# Access Compliance Report

## Public Rights-of-Way

Intersection ID: 46602	Main Street: PARK_RD_SHOPPING_CENTER_DR	Cross Street: PARK_RD	Location: NE
ADA ID: 516CB5257959	Ramp Type: PerpDiag	Initial Pass/Fail: Fail	Overall Compliance: No
		Severity Score: 8.75

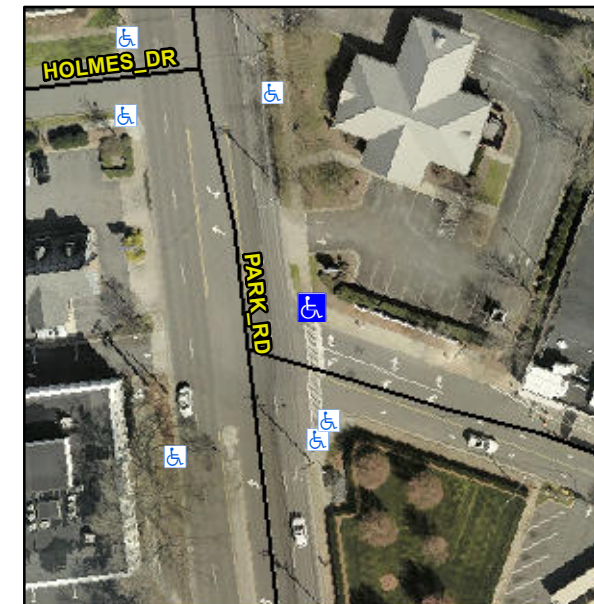
**Not Found, R304.5.1**

Compliance	Description	Data	Compliance	Description	Data
N/A	Ramp Length (in)	77.0	Yes	Ramp Slope (%)	5.3
No	Ramp Width (in)	45.0	Yes	Ramp XSlope (%)	0.4
N/A	Flare Type LT	N/A	N/A	Flare Type RT	N/A
N/A	Flare Slope LT (%)	N/A	N/A	Flare Slope RT (%)	N/A
N/A	Flare Traversable LT?	N/A	N/A	Flare Traversable RT?	N/A
N/A	Landing Length (in)	N/A	N/A	DWS Provided?	N/A
N/A	Landing Width (in)	N/A	N/A	DWS Contrast?	N/A
N/A	Landing Slope (%)	N/A	N/A	DWS Length (in)	N/A
N/A	Landing X Slope (%)	N/A	N/A	DWS Full Width?	N/A
N/A	Landing Curb? (Y/N)	N/A	N/A	DWS Offset (in)	N/A
N/A	Shared Landing?	N/A			
N/A	Gutter Ponding?	N/A	N/A	Gutter Slope (%)	N/A
N/A	Gutter Lip Ht (in)	N/A	N/A	Gutter X Slope (%)	N/A
N/A	Painted X Walk1?	No	N/A	Painted X Walk2?	Yes
	X Walk 1 Direction	To W		X Walk 2 Direction	To S
N/A	X Walk 1 Width (in)	N/A	N/A	X Walk 2 Width (in)	60.0
	X Walk 1 Slope (%)	1.5		X Walk 2 Slope (%)	1.2
	X Walk 1 X Slope (%)	0.2		X Walk 2 X Slope (%)	2.3

**Remove & Replace Curb Ramp With Two New Directional Ramps or Equivalent.**
